Planning Application Ref: 21/03380/FP Solar Farm on Land to the North and East of Great Wymondley, Hertfordshire

Response to Highways Consultations dated 16th December 2021 and 8th June 2021

Figure 1: Indicative locations for Temporary Construction Compounds and Parking

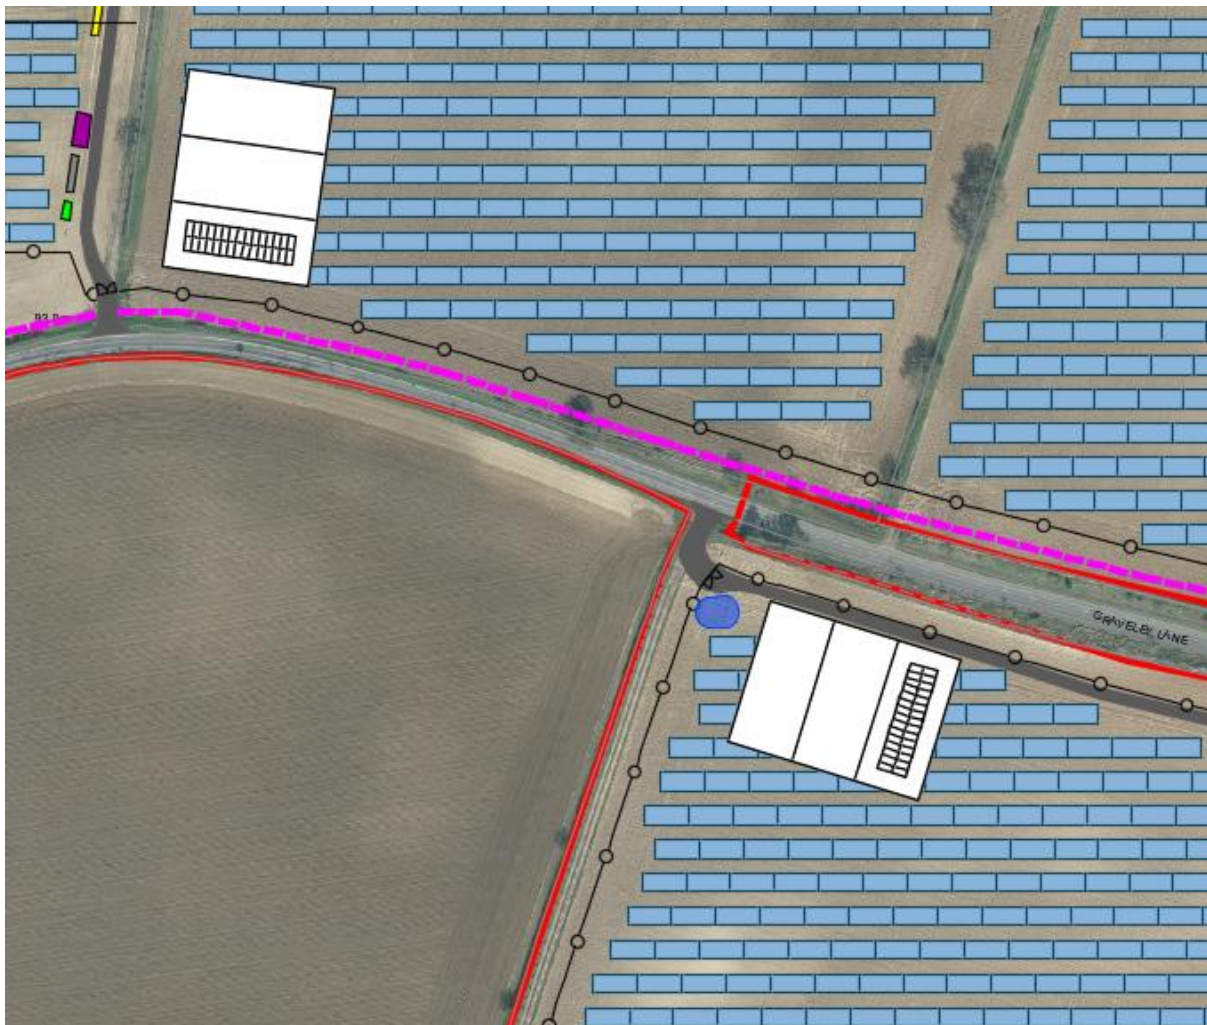
The details of construction compounds and temporary parking arrangements would be addressed in the Construction Traffic Management Plan (CTMP) for the project. It is suggested that the CTMP could be secured by a suitably worded planning condition and this approach is supported by the highway's consultation response, as set out below.

The indicative scale (approximately 50mx6m) and provisional location of the temporary construction compounds is illustrated on Figure 1 below. Each compound would include 30 parking spaces (to provide the maximum 60 spaces needed for the most intense period of construction), laydown areas and welfare facilities. The compounds would be reduced in scale as construction works need to progress within their footprint toward the end of the project.
